Jinnat Knitwears Limited (Sreepur) (Extension)

08 January 2023

Observations

BNBC minimum live load table.

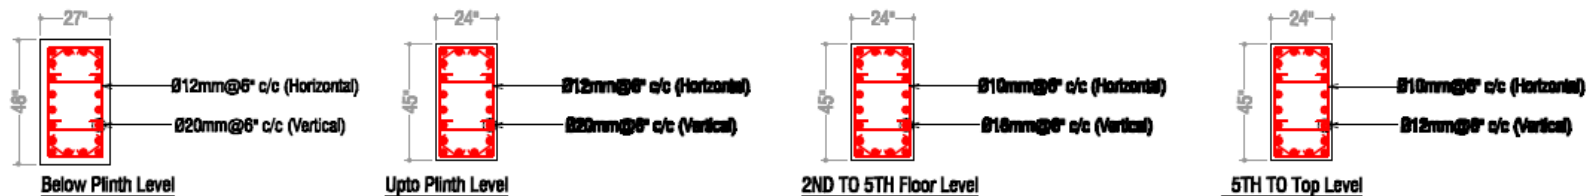
In design report, live load considered 4 kPa for general store.

As per BNBC, the minimum floor live load for light storage is 6 kN/m² (126 psf). The storage in this building is designed for 4 kN/m² live loads.

The building engineer is required to revise the load plan for storage area based on BNBC live load requirement and update the design report & FEA model accordingly.

SW- 1 DETAILS

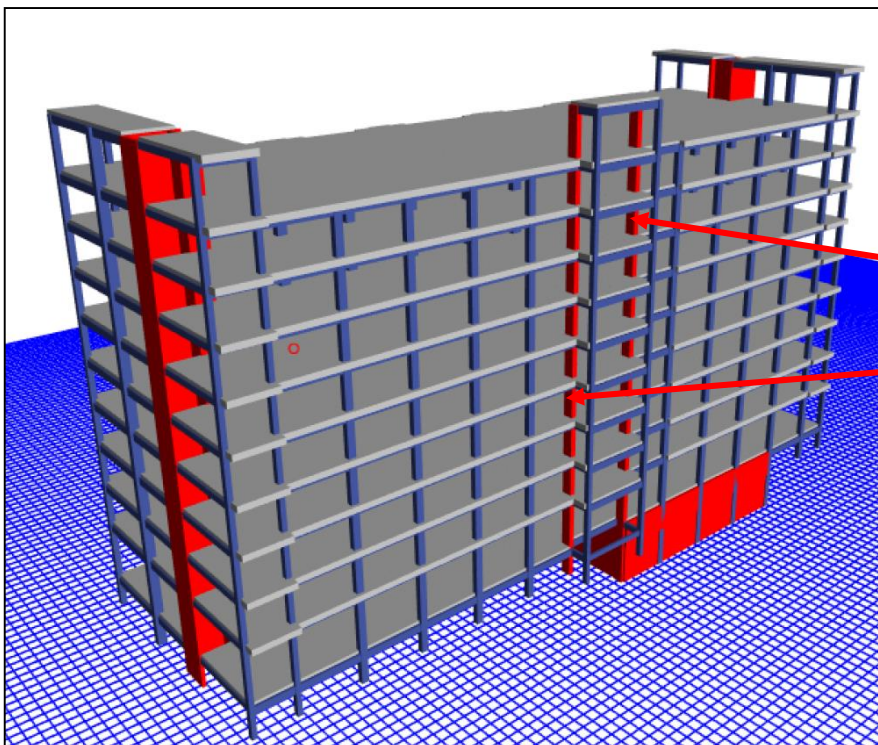
In design report the columns (at grid 7F & 8F) are considered as shear wall.

In design report and in the provided as-built drawing, the columns at grid 7F & 8F are considered as shear wall where the ratio of breadth/width of the columns < 0.4 . Building engineer is required to provide clarification for the consideration (columns as a shear wall) and revise the design report & FEA model accordingly and submit to RSC for review.

Floor beam layout at
1st floor level

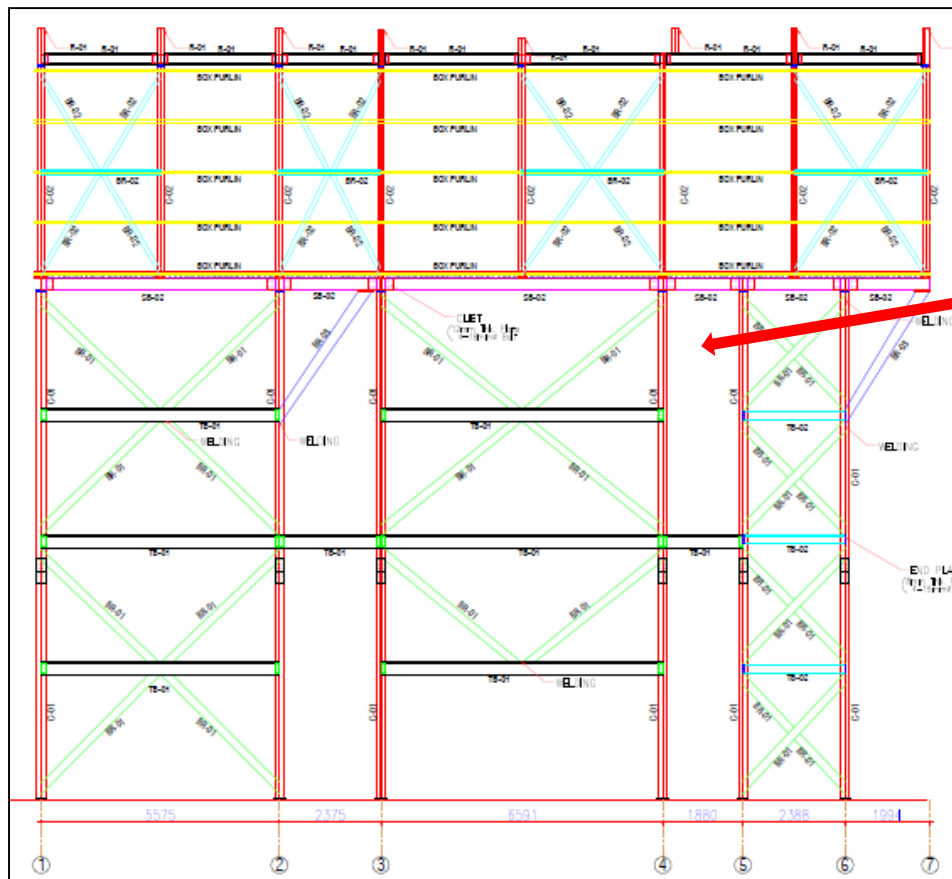
Some sub-beam found missing at on-site

Vertical bracing found missing in provided as-built drawing.

Discrepancies were observed between the provided as-built drawing and on-site condition. Building engineer is required to produce accurate as-built drawing.
